Minutes of Meeting
Perkasie Planning Commission
June 24, 2026

505 Constitution Avenue – Recycling Facility (Land Development Application)

PRELIMINARY SUBDIVISION AND
LAND DEVELOPMENT PLAN
FOR
PERKASIE PLACE RECYCLING CENTER

Reference: Preliminary Subdivision and Land Development Plans – Review #1
Perkasie Place Recycling Center
505 Constitution Avenue
TMP #33-009-001
Perkasie Borough, Bucks County, PA

TITLE SHEET

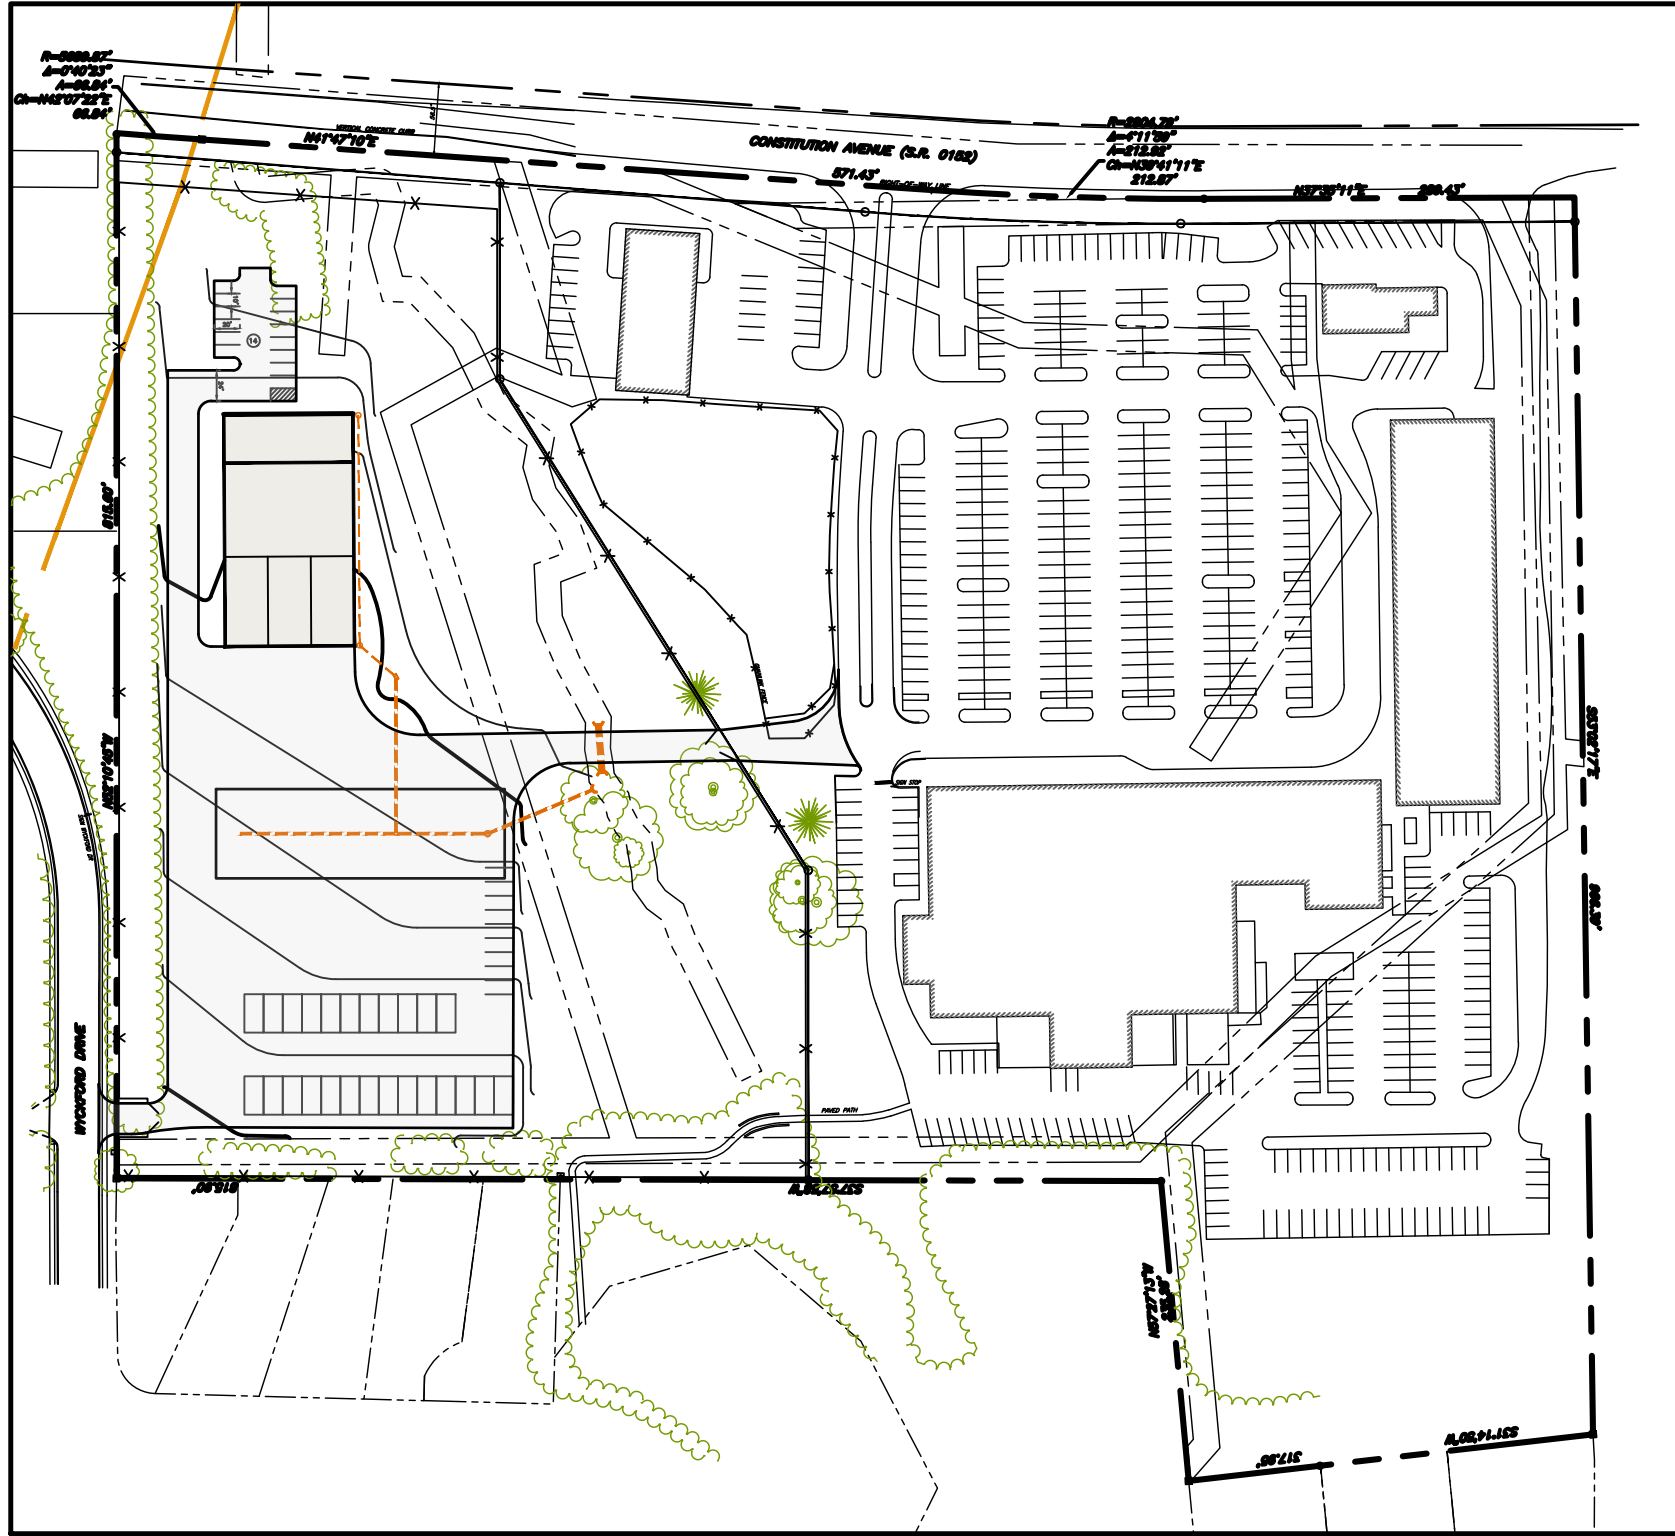
4. §186-20.I.(1) - The existing and proposed uses of Lots 1 and 2 should be listed in the Zoning Data tables on Sheet 1. The tables should also include any zoning requirements specific to the proposed use.

33. §164-68.B – The following information should be provided on the Subdivision Plan:
- a. The zoning tables for each lot on Sheet 1 should be shown on the plan. The tables should be revised to list the proposed setbacks for Lots 1 and 2. Also, any existing non-conformities should be noted on the plan.
